Access Compliance Report

Intersection ID: 10077	Main Street: E_35TH_ST	Cross Street: N_DAVIDSON_ST	Location: SW
ADA ID: A1F69E2AC3F5	Ramp Type: BlendTrans2	Initial Pass/Fail: Pass	Overall Compliance: No
		Severity Score: 20

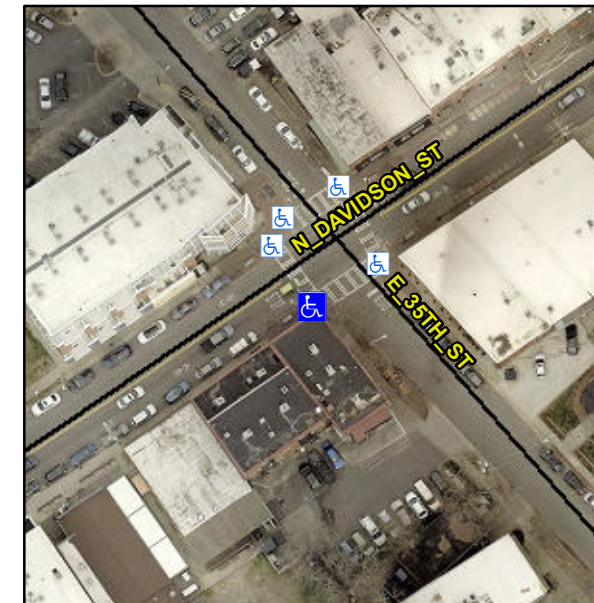
R304.2.3, R302.7.2, R304.5.4

Compliance	Description	Data	Compliance	Description	Data
N/A	Ramp Length (in)	25.0	Yes	BlendTrans Slope (%)	1.2
Yes	Ramp Width (in)	48.0	Yes	BlendTrans XSlope (%)	0.5
N/A	Flare Type LT	Sloped	N/A	Flare Type RT	Sloped
No	Flare Slope LT (%)	N/A	No	Flare Slope RT (%)	N/A
N/A	Flare Traversable LT?	Yes	N/A	Flare Traversable RT?	Yes
N/A	Landing Length (in)	N/A	Yes	DWS Provided?	Yes
N/A	Landing Width (in)	N/A	Yes	DWS Contrast?	Yes
N/A	Landing Slope (%)	N/A	Yes	DWS Length (in)	24.5
N/A	Landing X Slope (%)	N/A	Yes	DWS Full Width?	Yes
N/A	Landing Curb? (Y/N)	No	Yes	DWS Offset (in)	1.0
N/A	Shared Landing?	No			
Yes	Gutter Ponding?	No	No	Gutter Slope (%)	6.9
No	Gutter Lip Ht (in)	1.0	Yes	Gutter X Slope (%)	0.9
N/A	Painted X Walk1?	Yes	N/A	Painted X Walk2?	Yes
	X Walk 1 Direction	To NE		X Walk 2 Direction	To NW
	X Walk 1 Width (in)	113.0		X Walk 2 Width (in)	80.0
	X Walk 1 Slope (%)	6.5		X Walk 2 Slope (%)	2.9
	X Walk 1 X Slope (%)	4.3		X Walk 2 X Slope (%)	3.0

Remove & Replace Curb Ramp With Two New Directional Ramps or Equivalent. Remove & Replace Gutter.
